**COMMUNITY DEVELOPMENT DEPARTMENT  
PLANNING STAFF ANALYSIS  
CONDITIONAL USE**

**CASE NUMBER:** 2015-0041

**REQUEST:** Conditional use to allow 14 dwelling units per acre in the gR-4 (Girdwood multiple-family residential) district

**SITE ADDRESS:** 180 Taos Road

1 SITE PLAN - ONE WAY DRIVE  
SCALE: 1" = 10' @ FULL SIZE 24X36 SHEET

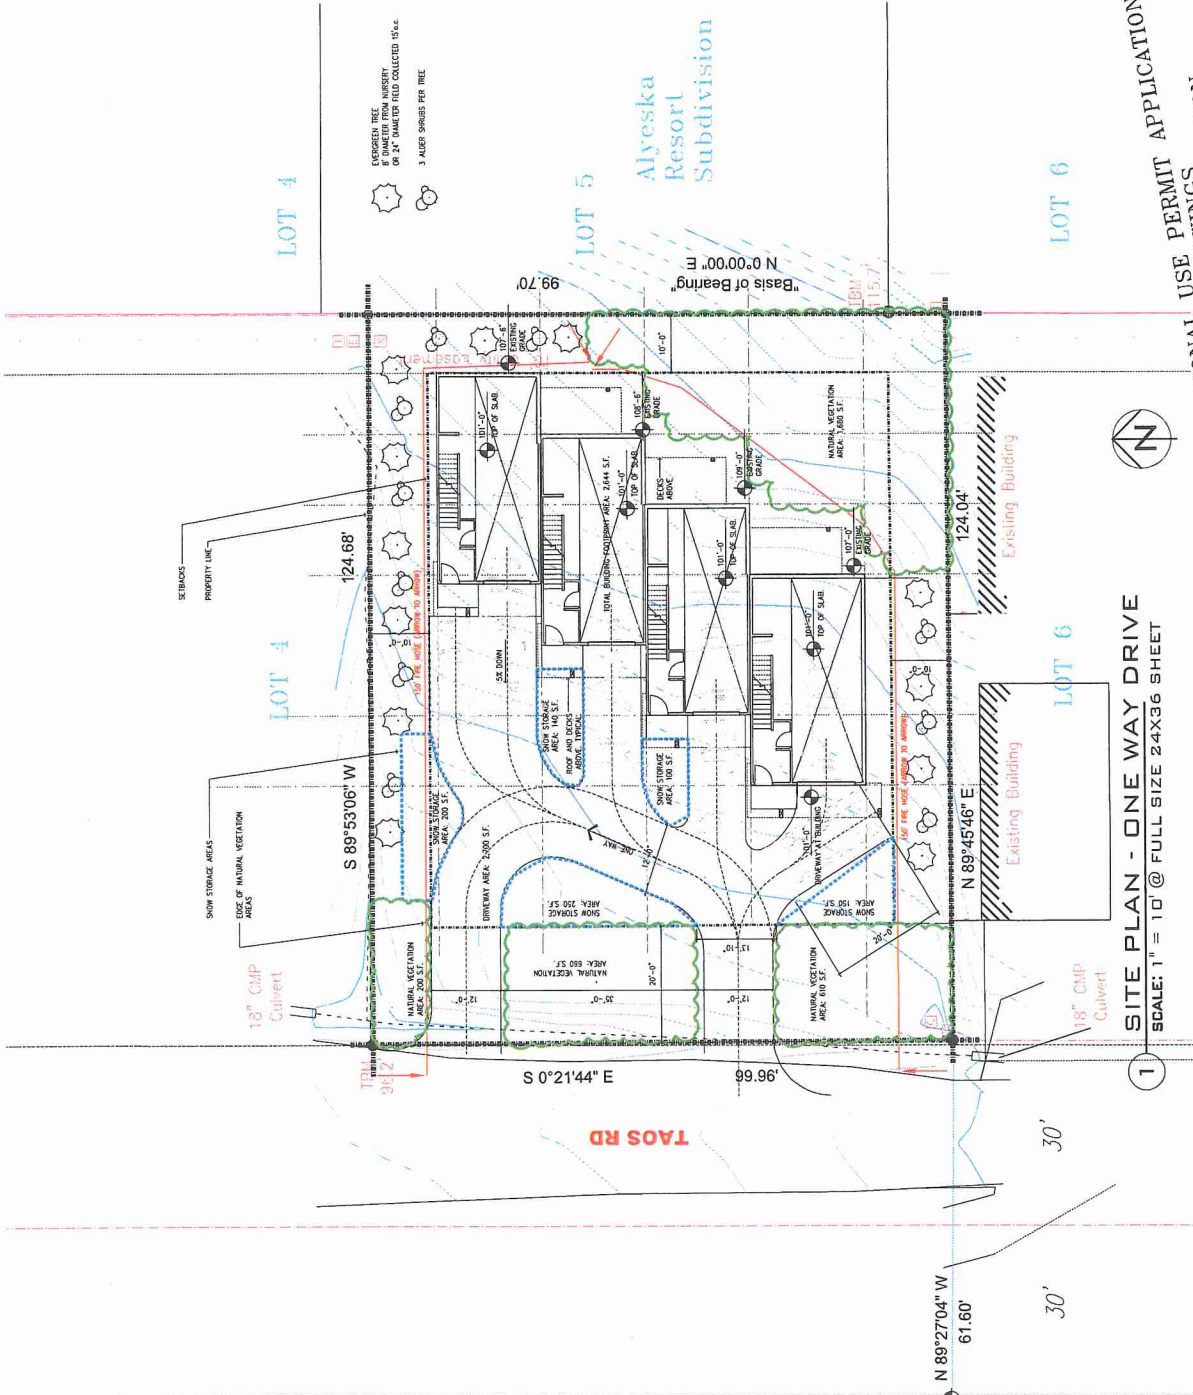
- L. Off-street parking standards:** The parking requirement of nine spaces is met. The site plan shows no parking spaces located within the required setbacks. The driveway must be paved in accordance with AMC 21.09.070L.8.

3. Revise the site plan to show a paved driveway, in accordance with AMC 21.09.070L.8.
4. Revise the building elevations to show concrete board or CMU in the areas that are affected by snow accumulation and rain splashback.

ZELMER TOWNHOUSES  
GIRDWOOD, ALASKA  
EAST ELEVATION

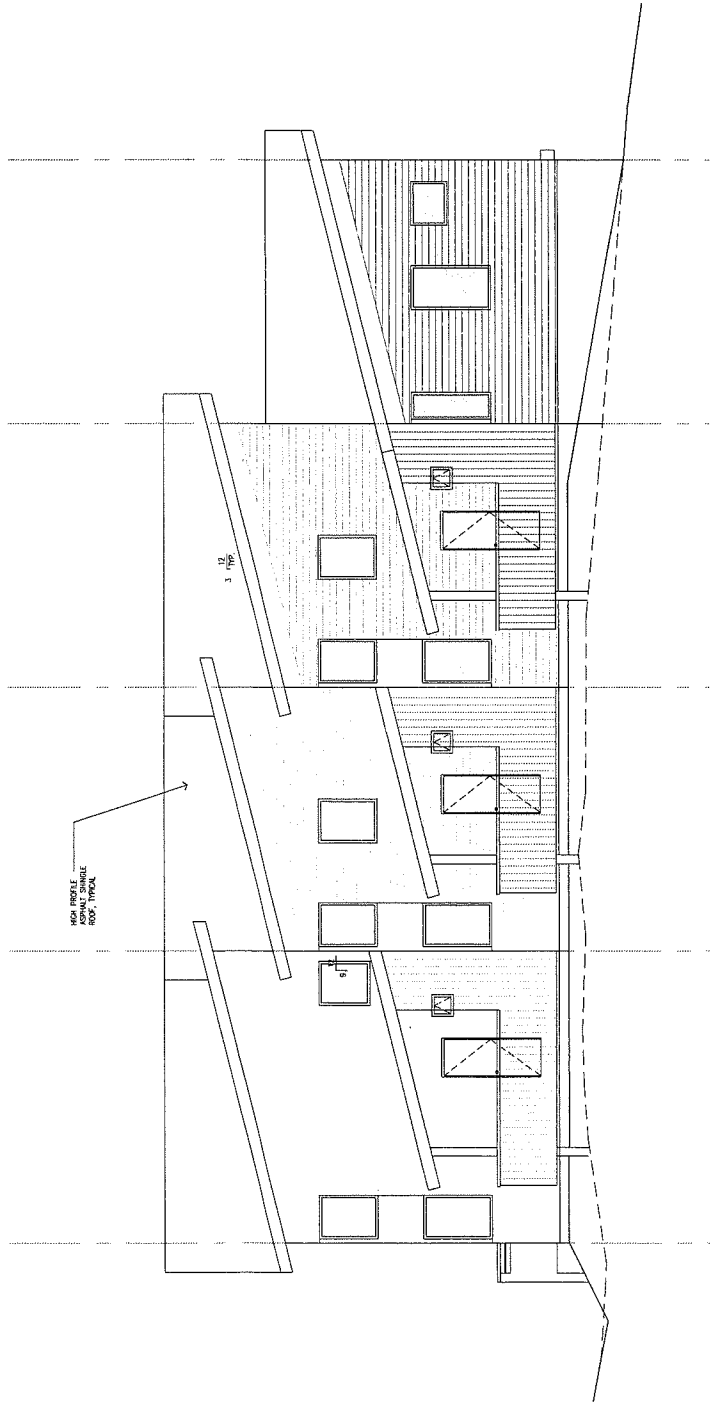
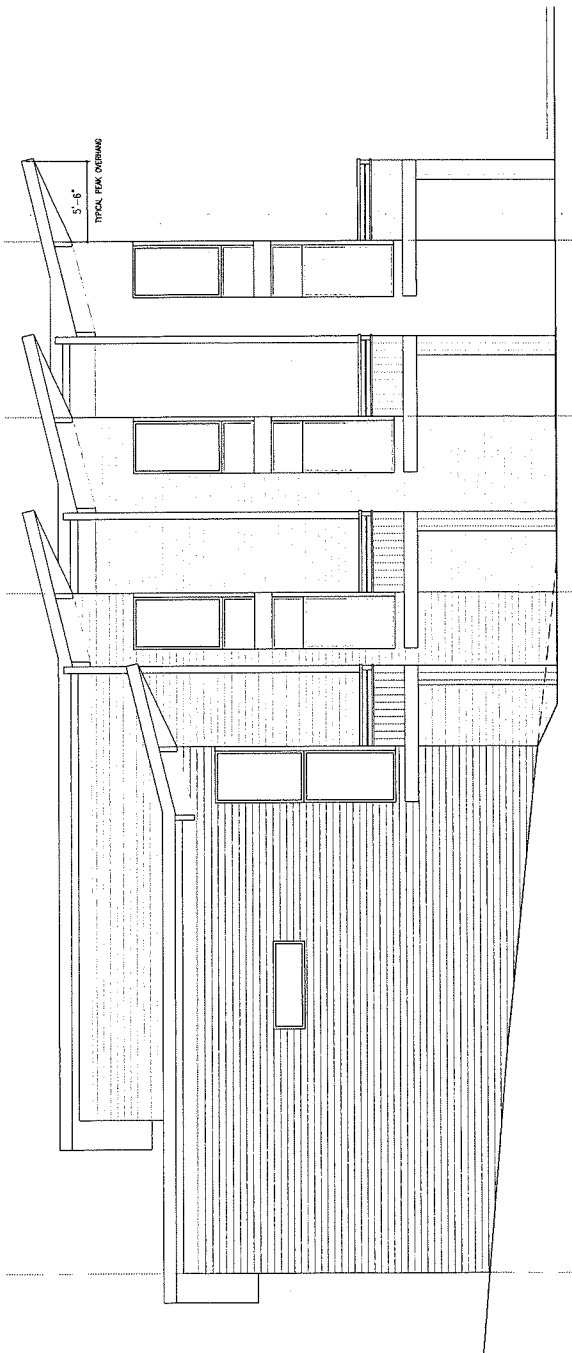
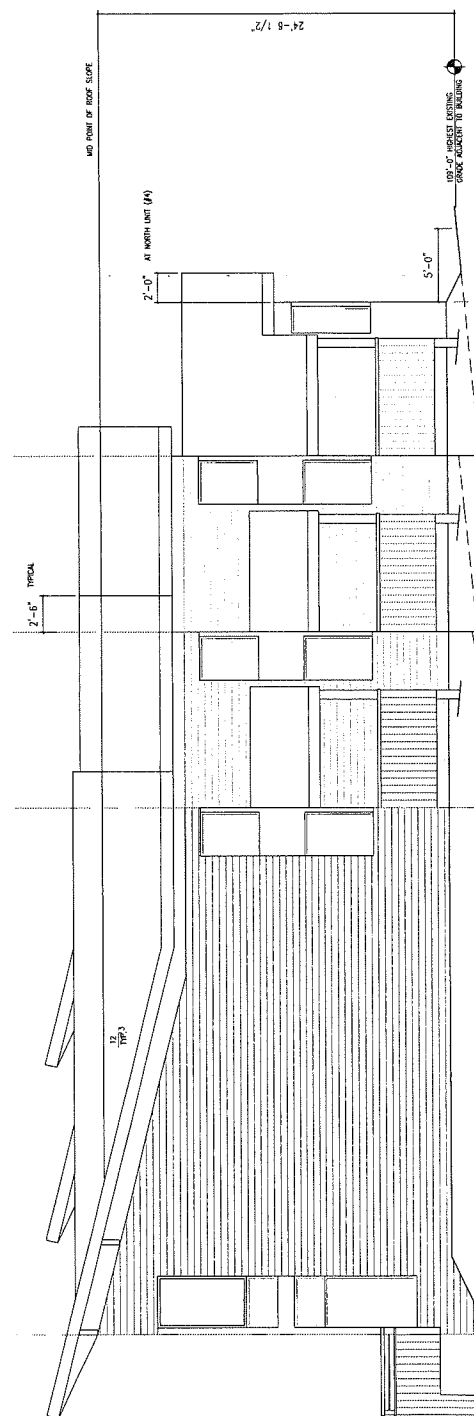
The building elevations show cedar siding on the lower sections of the building. The petitioner has stated verbally that they will revise the plans to show concrete board or concrete masonry unit in the areas that are affected by snow accumulation and rain splashback.
